# **LOWER SNAKE RIVER ICE HARBOR and LOWER MONUMENTAL LOCKS and DAMS**

**Adult Fishway Systems  
Emergency Auxiliary Water Supply  
Phase II - Technical Report**

**August 1999**

An independent technical review was performed on this Phase II - Technical Report at the 60 percent level of completion. The quality control plan for the technical review is included in appendix A. The technical review comments and the responses to them are included in appendix B.

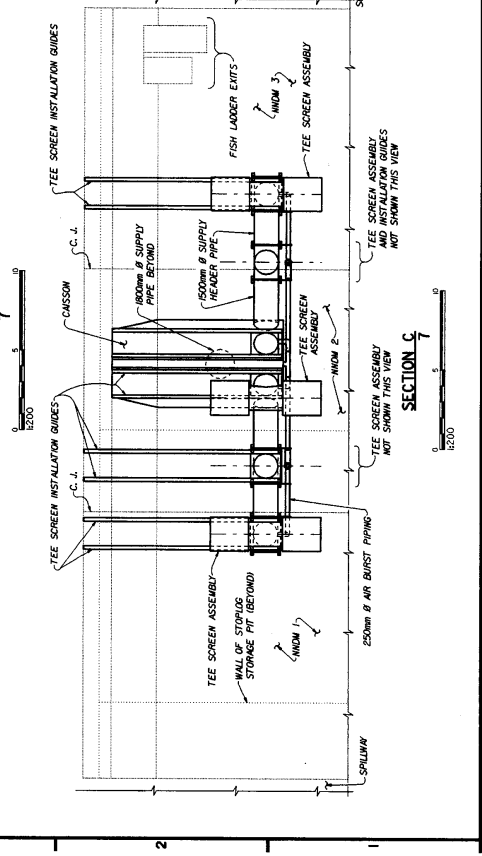
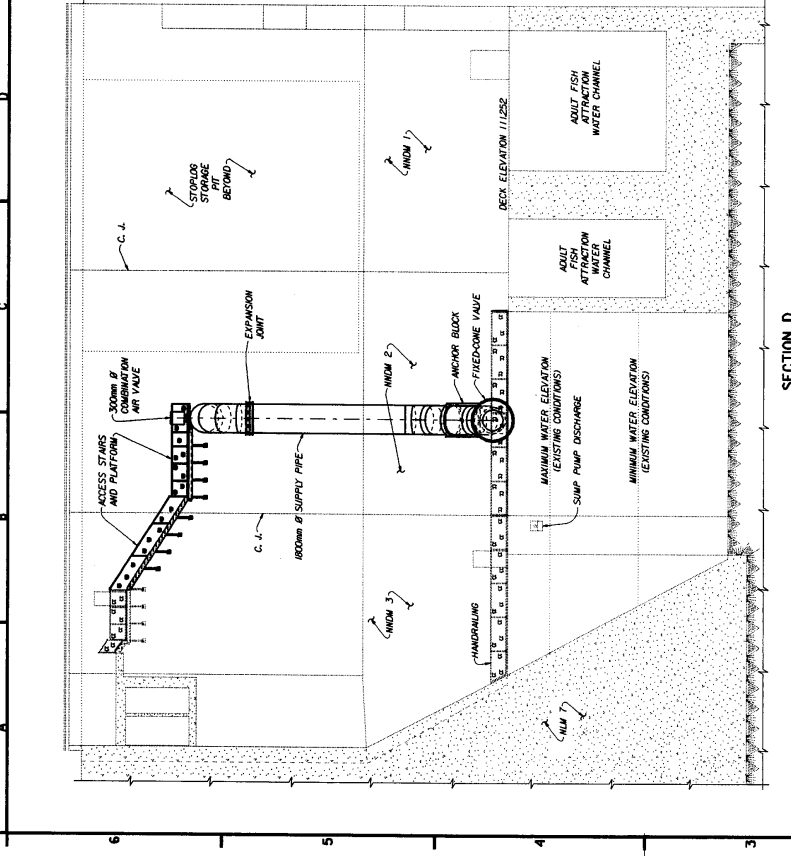
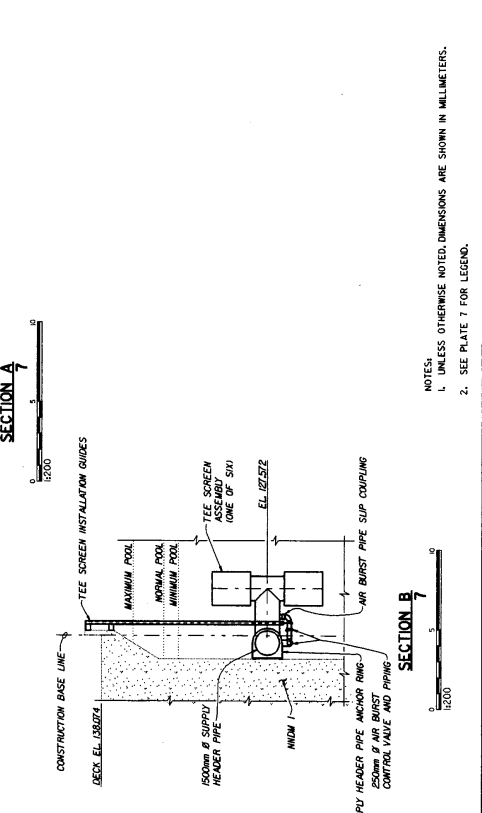
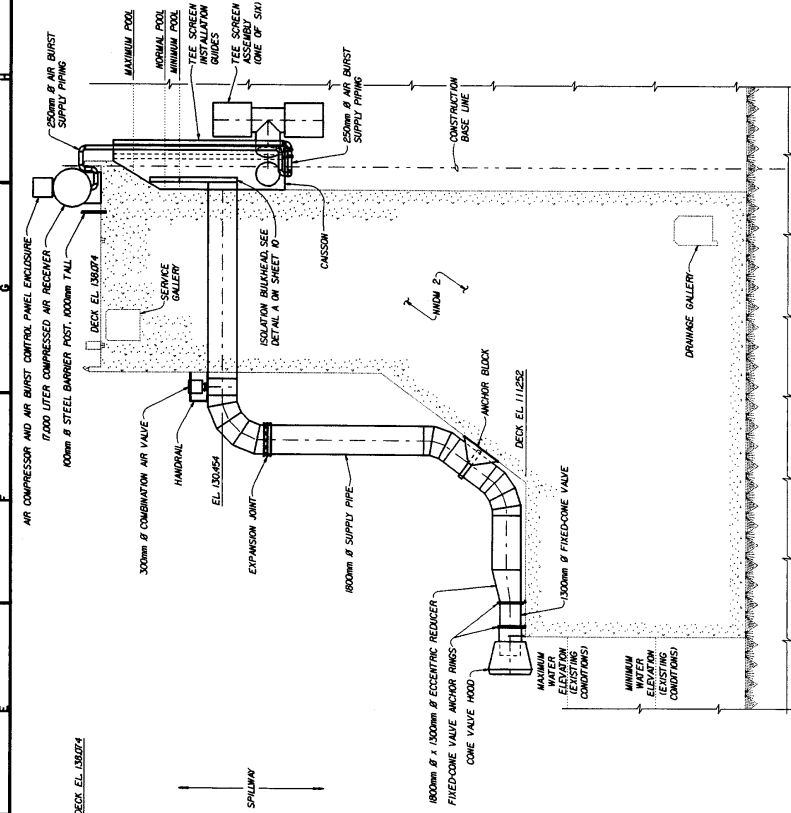
Plate 7	Is there a loading scenario may cause this structure to want to float, slide or overturn? This may include seismic with unbalanced head.	A		The structure is ok for overturning.	<i>MC</i>
6	Plate 7	Will there be a loading scenario that causes the walls of slabs in this structure to become overstressed?	A		Will perform further analysis.	<i>MC</i>
8	Plate 15	What carries the weight of the in-line sleeve valve? Is the existing structure adequate to carry these loads?	A		If this method is selected, we can perform an analysis during plans and specs.	<i>MC</i>
9	Plate 35	Can this be used for Ice Harbor for temporary caisson option?	A		Possibly	<i>MC</i>
10	Plate 32	Any selected method should include a consideration of seismic effects upon the existing nonoverflow section. However, the effects are probably minor.	A		If this method is selected, we can perform an analysis during plans and specs.	<i>MC</i>

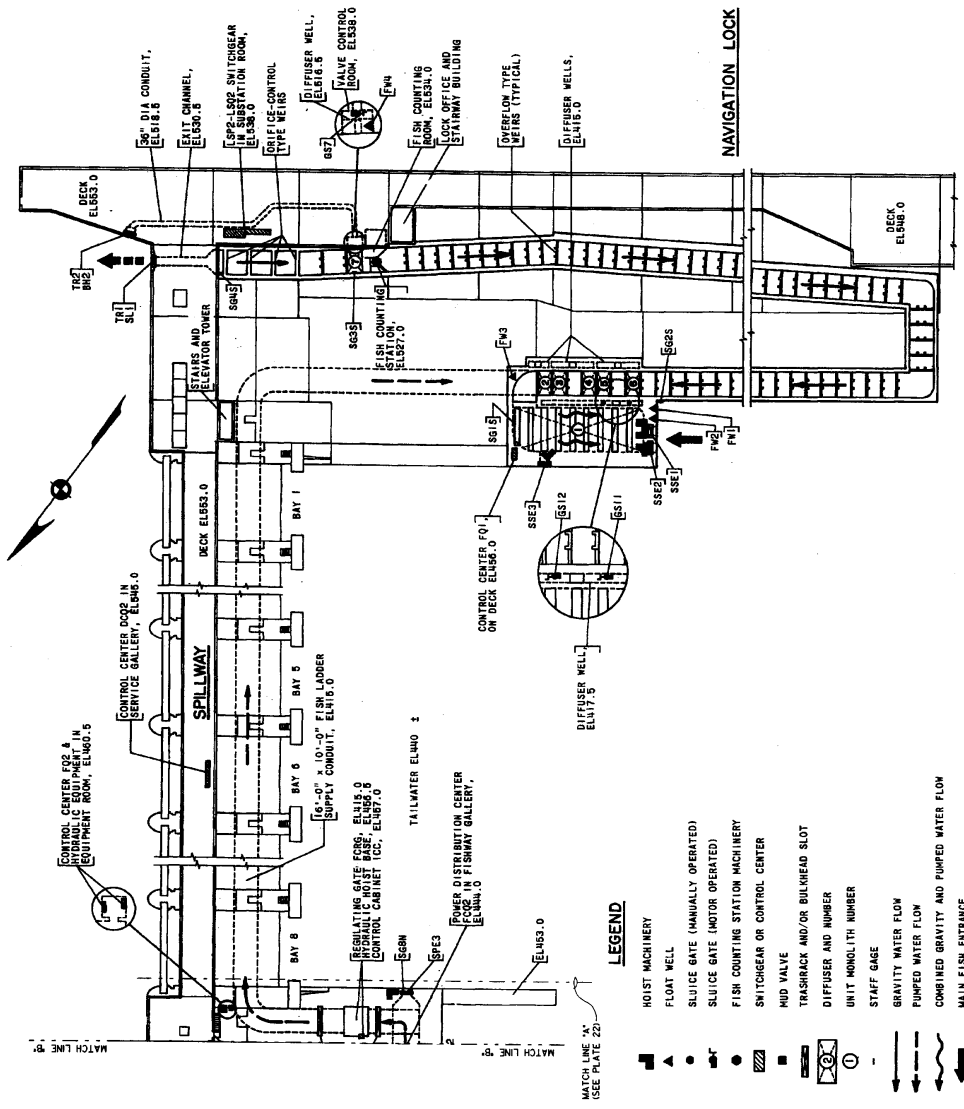
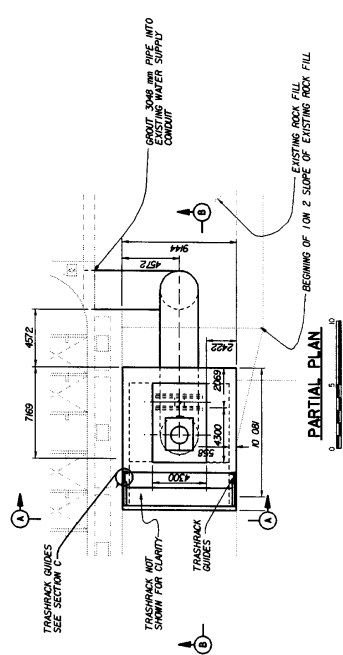
12.	Plate 20	List conduit sizes in SI units to be consistent with the report format.				A		C			✓
13.	Plate 20	Somewhat confusing to show the FSQ1 switchboard connected to both the existing and revised 1-Lines of FSP1.				A		C			✓
